Application for Works Approval

Works Approval Number	W6488/2021/1
Applicant	Beacon Mining Pty Ltd
ACN	603 853 916
File Number	DER2020/000654
Premises	Jaurdi Gold Project Tailings Storage Facility Mining Tenement M16/529, COOLGARDIE WA 6429 As defined by the Premises maps attached to the issued works approval
Date of Report	14 July 2021
Decision	Works approval granted

Attachment 4: Jaurdi TSF monitoring bores

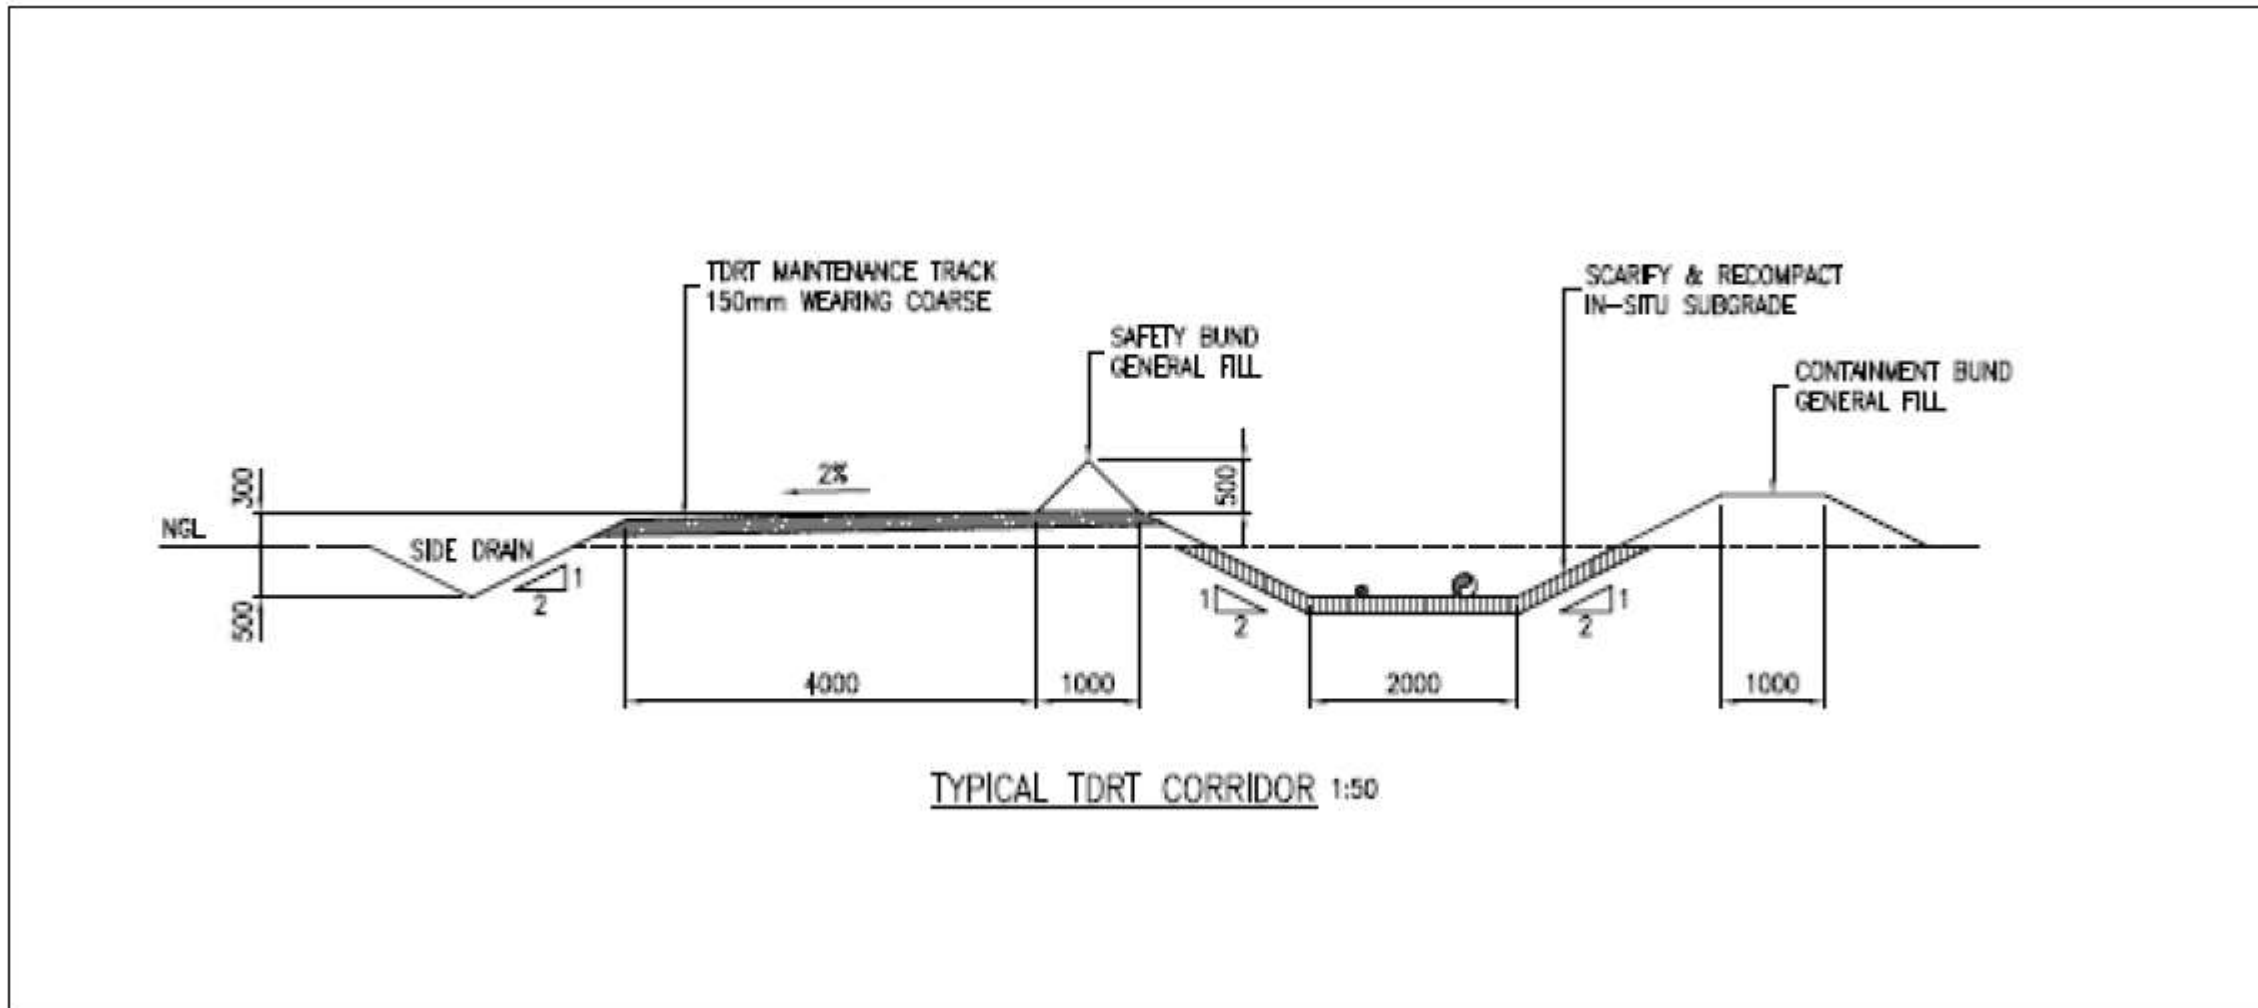
Monitoring of the groundwater expected to be impacted by seepage from the TSF is through a monitoring borefield as shown in Attachment 4. The bores installed in this borefield are to be designed such that they may be converted to pumping bores in the event that the trigger proposed by the applicant (7mbgl) is exceeded. The pumping of the groundwater to lower the standing water levels is for the protection of the surrounding vegetation as the seepage water is saline to hypersaline and would impact the health of the vegetation if it reaches the root zone.

The use of a monitoring bore for pumping renders the bore inadequate for continued monitoring as the drawdown in the bore makes assessment of the SWL for that area uncertain. To address this, conditions have been included in the works approval that specify a bore being used for pumping can no longer be used for monitoring, and that it must be replaced by another monitoring bore in the vicinity of the pumped bore.

Another contingency action in the event of the SWL trigger being exceeded is that a seepage interception trench of approximately 2m deep and fitted with a sump be installed along the south eastern side of the TSF. This is the area that is estimated to be downstream of the TSF in terms of groundwater flow and should allow for interception and recovery of mounded groundwater or seepage to limit the area of impact on the surrounding environment.
